**SUSQUEHANNA STEAM ELECTRIC STATION
PROPOSED AMENDMENT NO. 280 TO UNIT 1
FACILITY OPERATING LICENSE NPF-14 AND
PROPOSED AMENDMENT NO. 249 TO UNIT 2
FACILITY OPERATING LICENSE NPF-22: REVISE
TECHNICAL SPECIFICATION 3.4.10 "RCS PRESSURE
AND TEMPERATURE (P/T) LIMITS"
PLA-5933**

**Docket Nos. 50-387
and 50-388**

ENCLOSURE TO PLA-5933

UNIT 1 AND UNIT 2 CHANGES TO TECHNICAL SPECIFICATION 3.4.10

FIGURE 3.4.10-1
System Hydrotest Limit with Fuel in Vessel (Curve A)
for 35.7 EFY

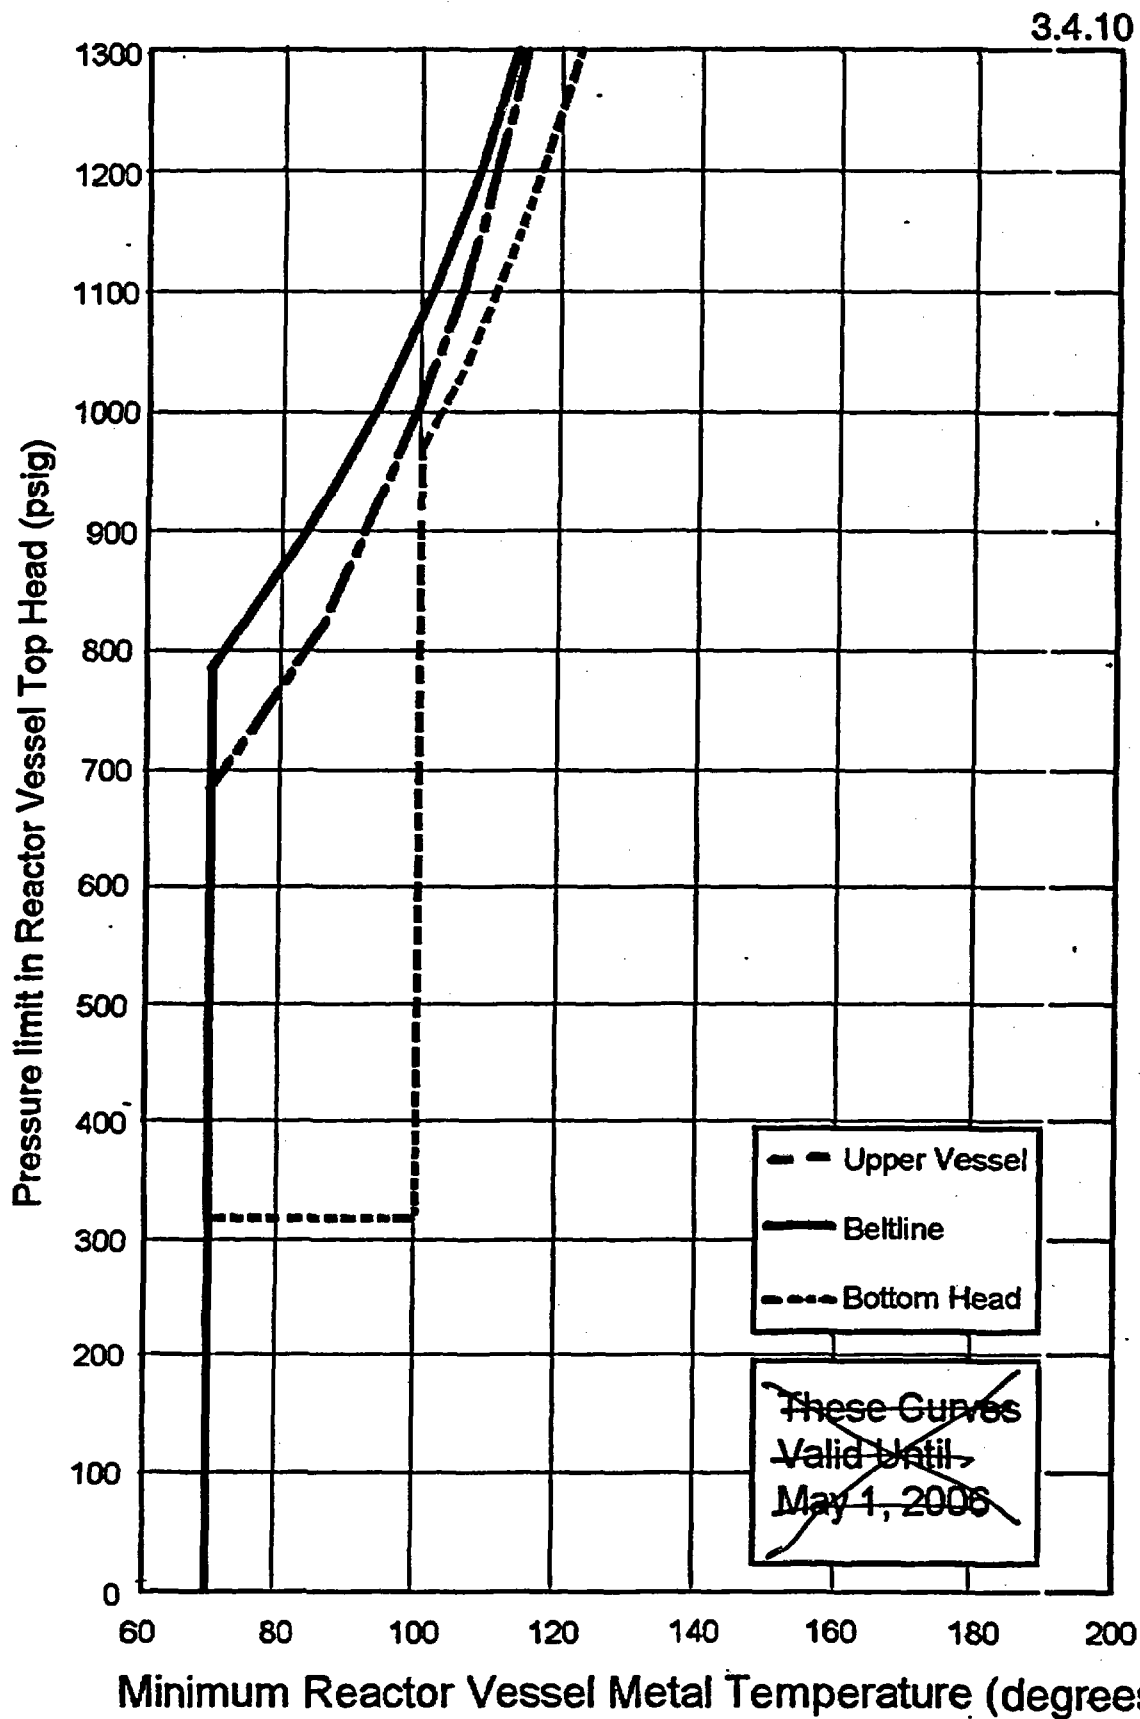
The proposed changes are to TS Figures 3.4.10-1, 3.4.10-2, and 3.4.10-3, which show the P/T limits curves for inservice leakage and hydrostatic testing, non-nuclear heatup and cooldown, and criticality, respectively.

The proposed P/T limit curves are valid for 35.7 EFPY for SSES Unit 1 and 30.2 EFPY for SSES Unit 2. The plotted values of the proposed curves have been developed to be identical to the plotted values on the present curves, contained in NRC approved Amendments 200 and 197 for Unit 1 and Unit 2 respectively. Only the limit on the validity of the curves has changed. This change in validity is due to using new BWRVIP RAMA Code (Reference 1) fluence calculation methodology recently approved by the NRC. The new fluence calculations also incorporate the proposed EPU power level of 3952 MWT.

No. The proposed changes request that the P/T limits curves in TS 3.4.10, "RCS Pressure and Temperature (P/T) Limits" be revised by removing the valid date and replacing it with the Effective Full Power Years of radiation exposure limit on each of the P/T curves for SSES Units 1 and 2.
